Subject ▶ Change of Ball Bearing

For Models ▶ 9005B, 9006B(Angle Grinder)

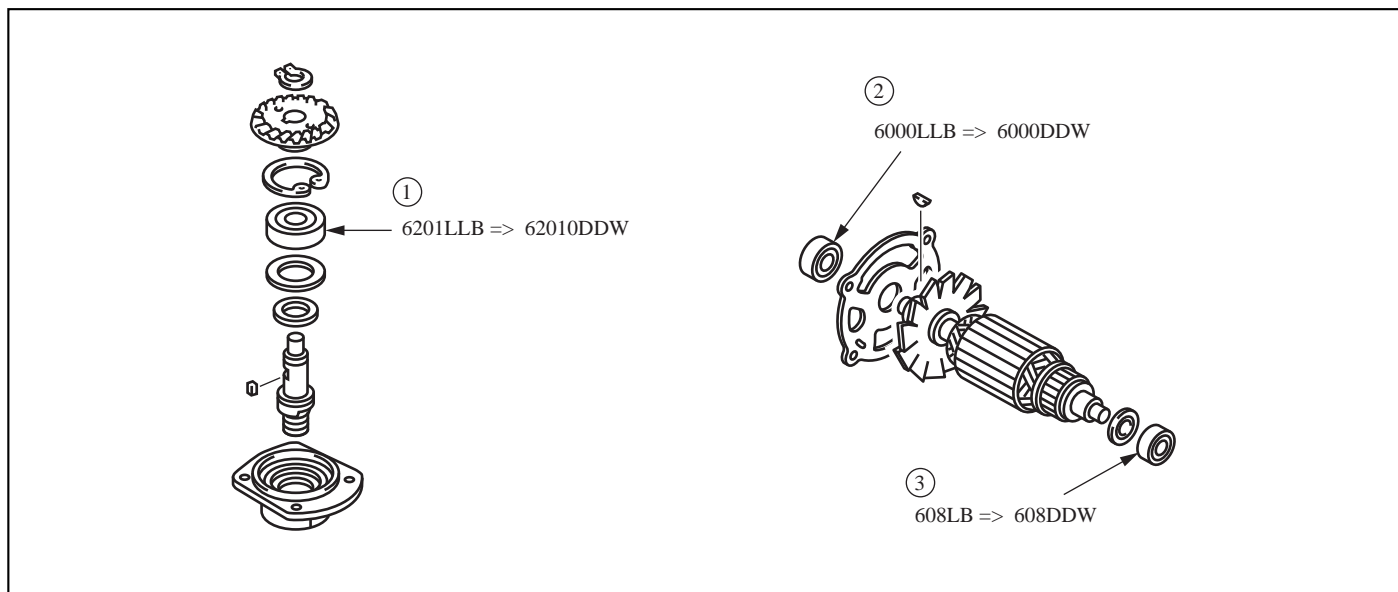
Description ▶ As illustrated below, Ball Bearings has been changed, for improvement in endurance.

- (1)6201LLB(seal color:Black) => 6201DDW(seal color:Green)
- (2)6000LLB(seal color:Black) => 6000DDW(seal color:Green or Blue)
- (3)608LB(seal color:Black) => 608DDW(seal color:Green)

9005B : From serial No. 1252481
9006B : From serial No. 106042
